## NEEDHAM PLANNING BOARD Tuesday December 21, 2021 7:15 p.m.

# MAJOR PROJECT SITE PLAN REVIEW SPECIAL PERMIT AMENDMENT TO DECISION Application No. 2009-06

#### Town of Needham December 21, 2021

PLAN OF LAND DATED SEPTEMBER 28, 1933 BY P.D.G. HAMILTON, CIVIL ENGINEER

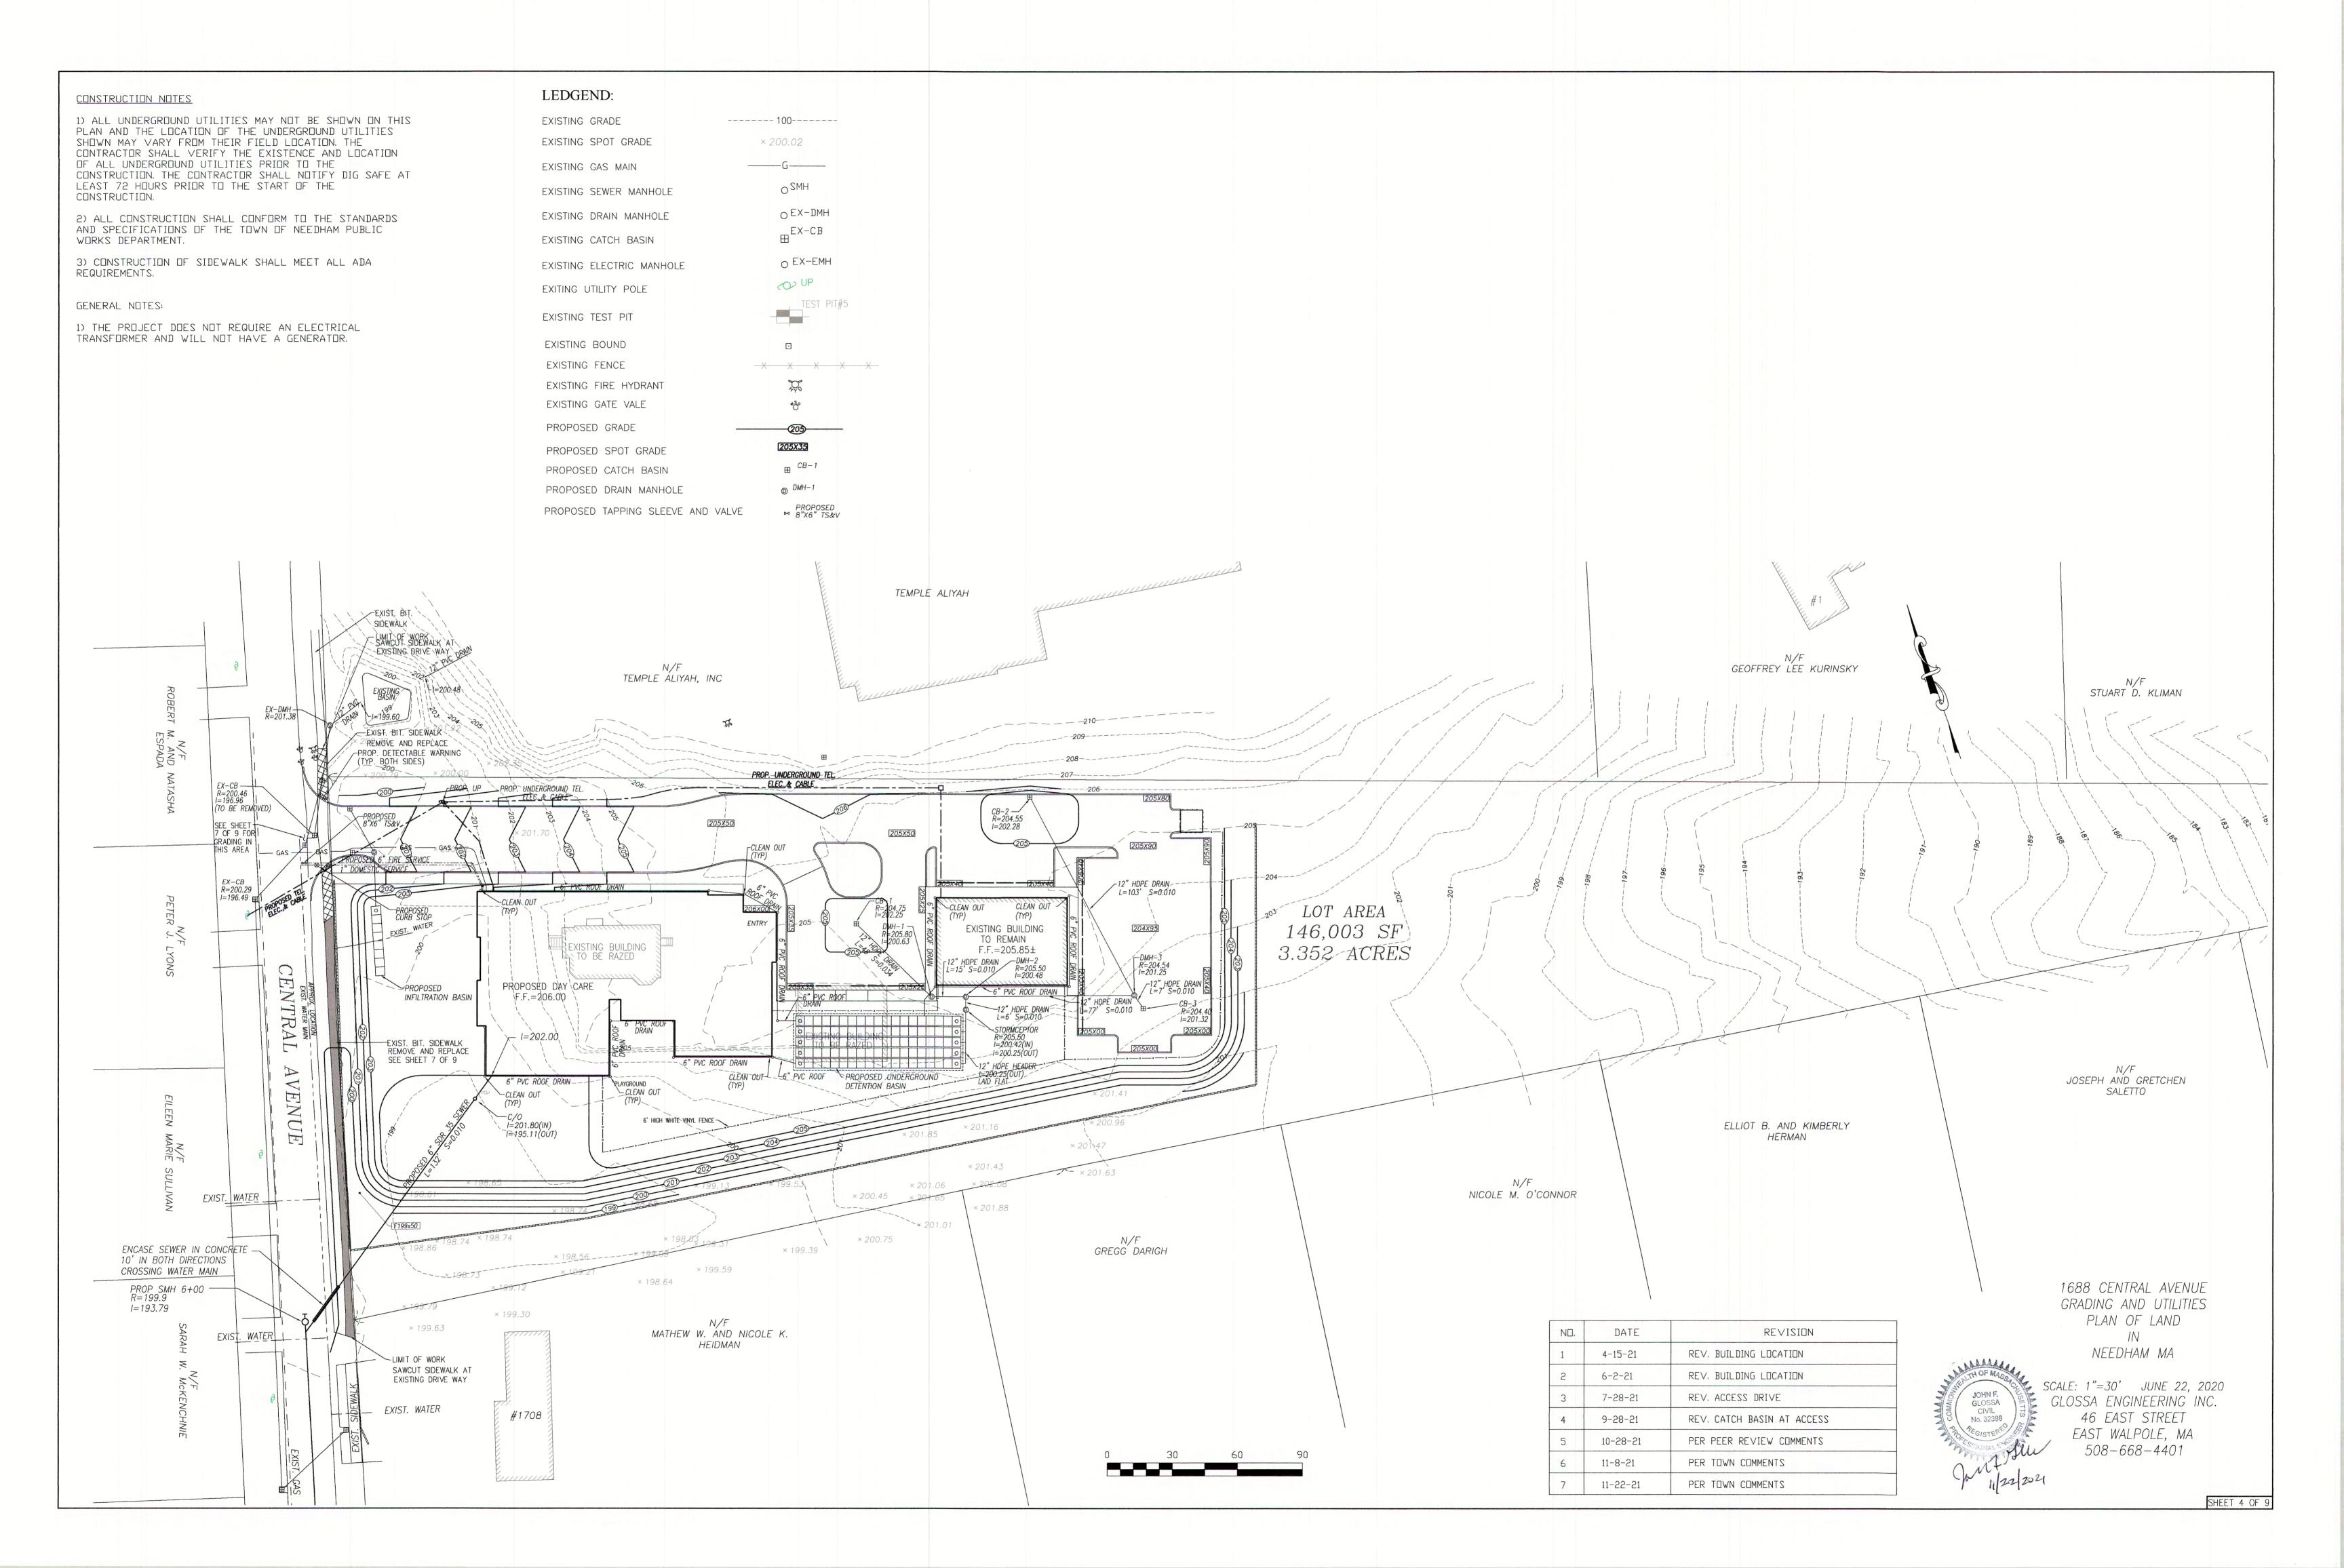
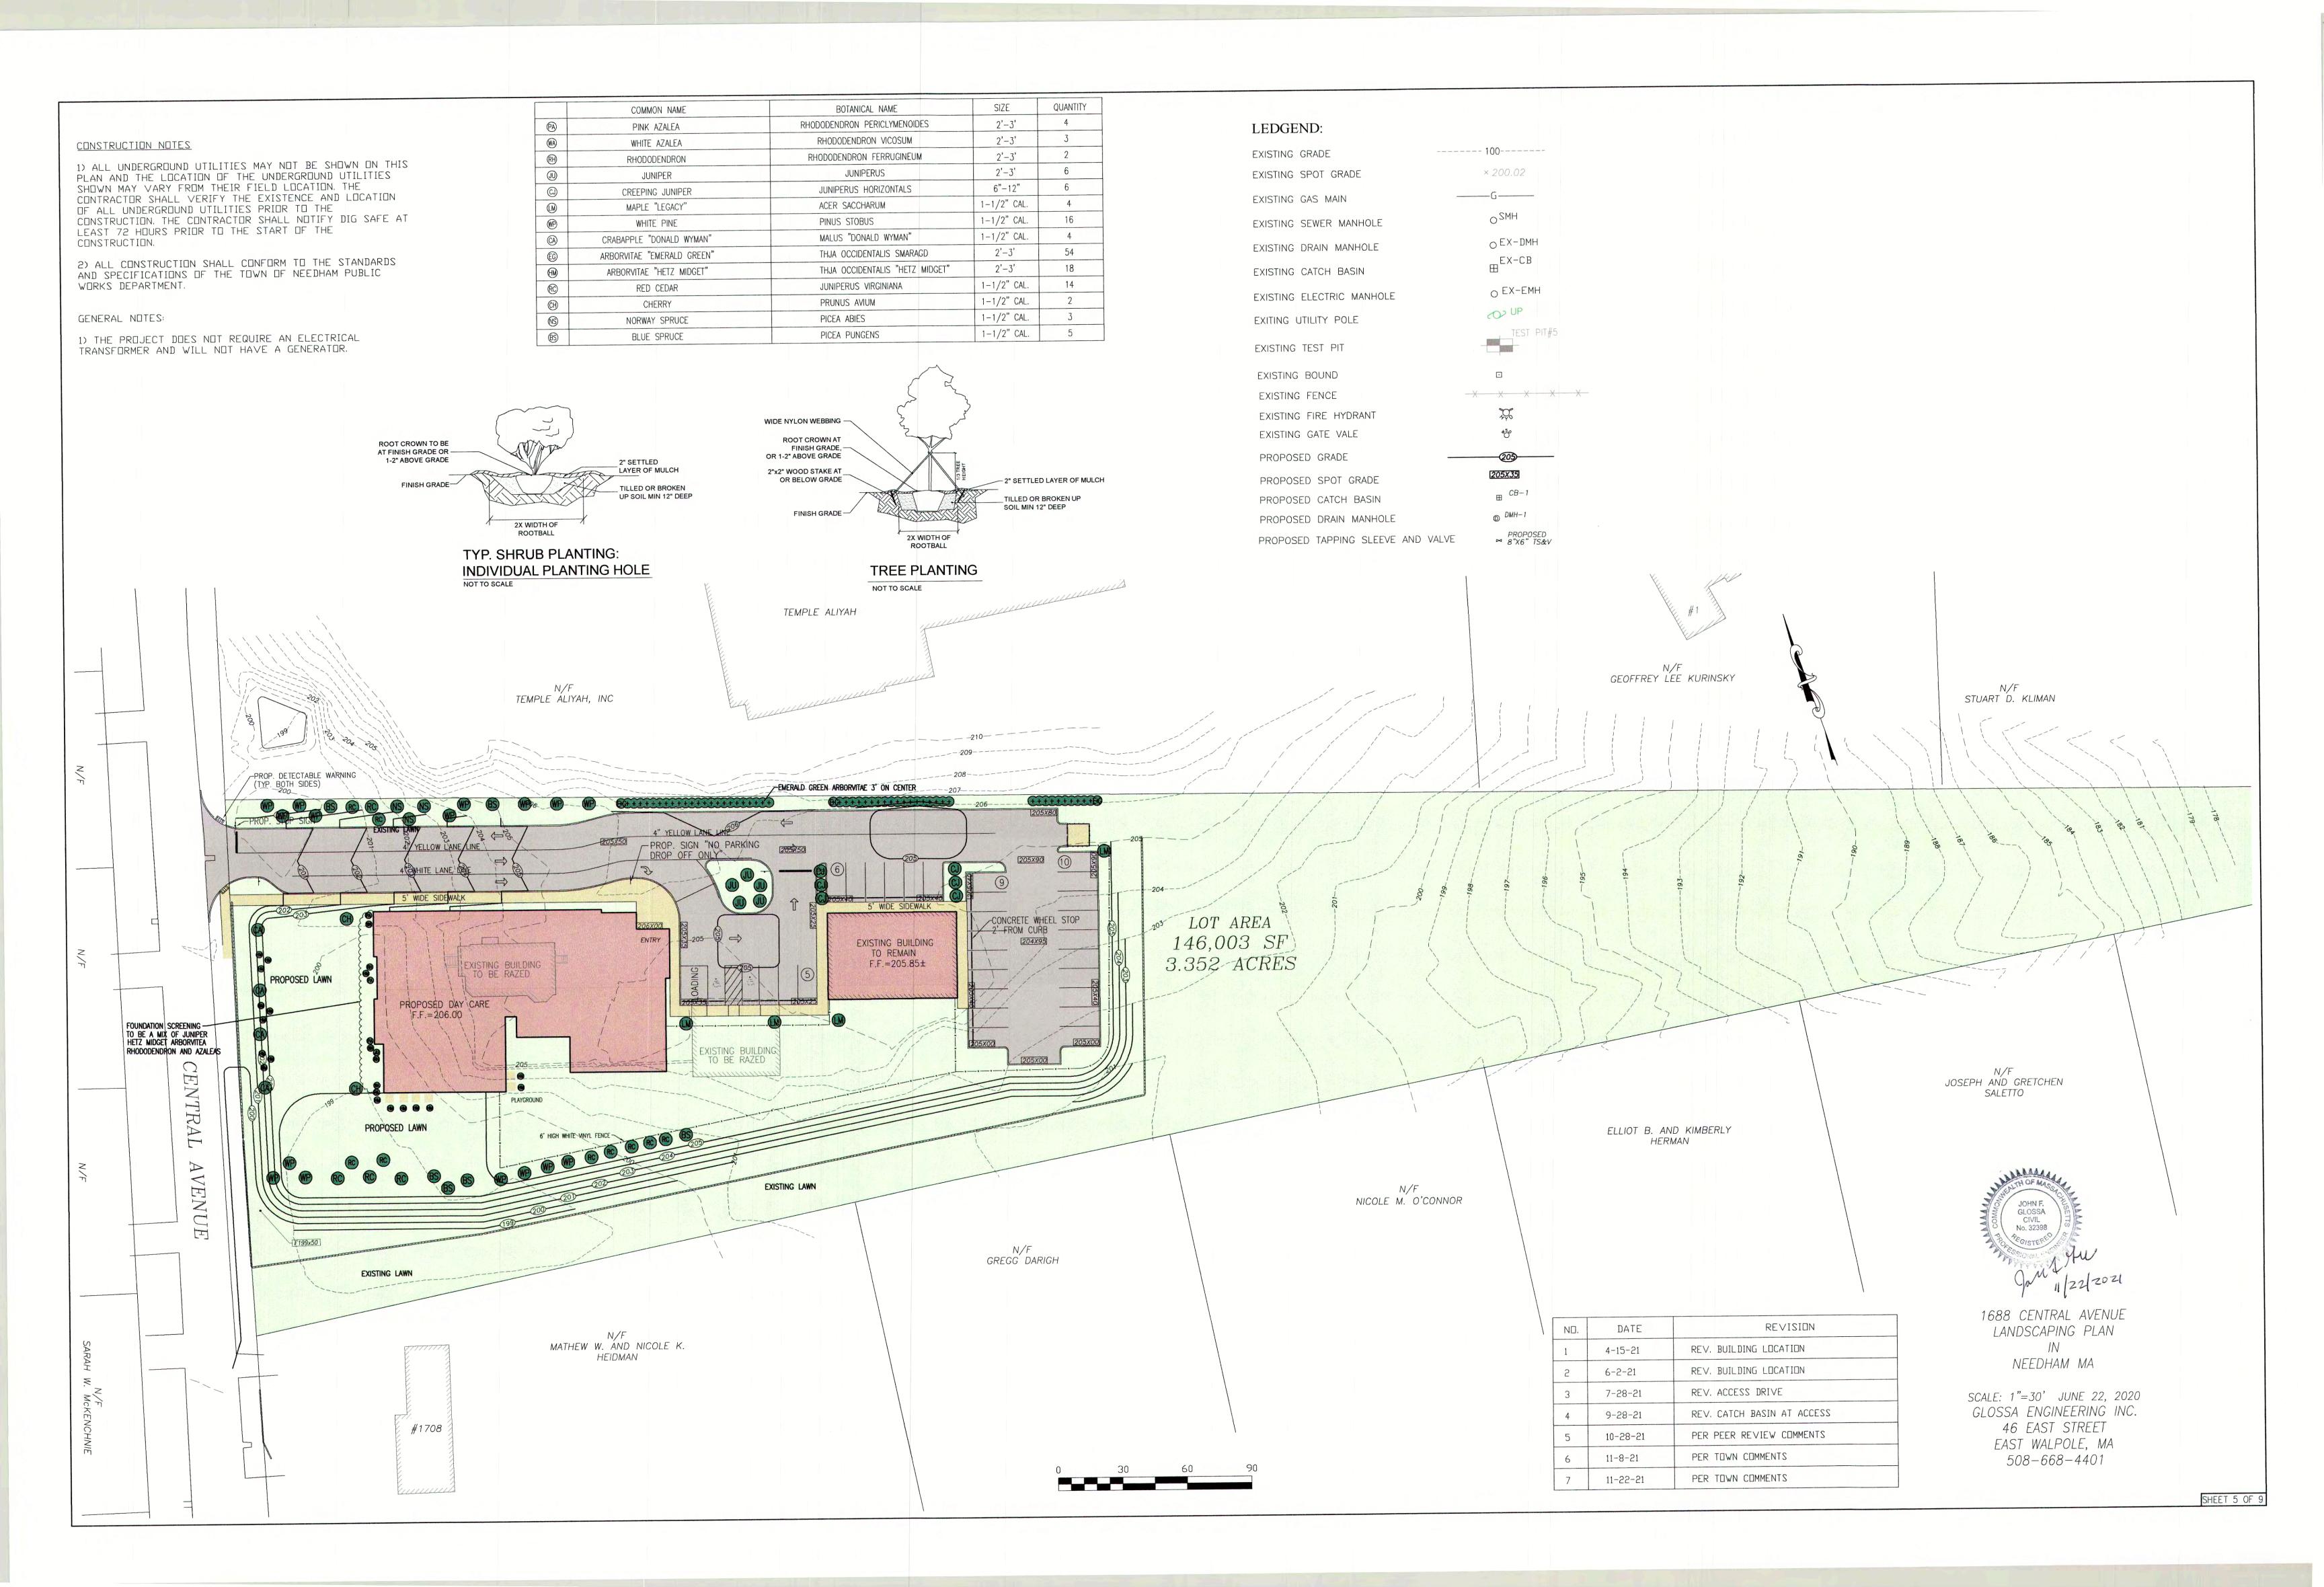
- a) Sheet 4 Proposed grades of the centerline of the driveway apron do not make sense. It appears to slope DOWN from the edge of road to the front of crosswalk by more than 2% and then slope up to the back of the crosswalk by more than 4%

- b) <u>Sheet 4 The spot grades 200x68 and 200x74 indicate the apron slope of about 1% UP at the sidewalk openings and a 1.8%-2.0% slope across the sidewalk/crosswalk, the apron portion should be sloped greater than the crosswalk portion.</u>

- c) Provide grades on sidewalk approaching driveway. It is unclear if the sidewalk slopes to the driveway or is level with the crossing.
- d) Sheet 4 Limit of work on the sidewalks should be indicated (also relates to Comment 2)

- e) Sheet 6 Detail should be provided for the proposed driveway apron.
- f) Sheet 8 & 9 Proposed CBs should be labeled and Existing CB to be removed should be labeled

- g) Sheet 10 Either delete labels on CBs (not relevant for lighting) or correctly label the Existing CB to be Removed
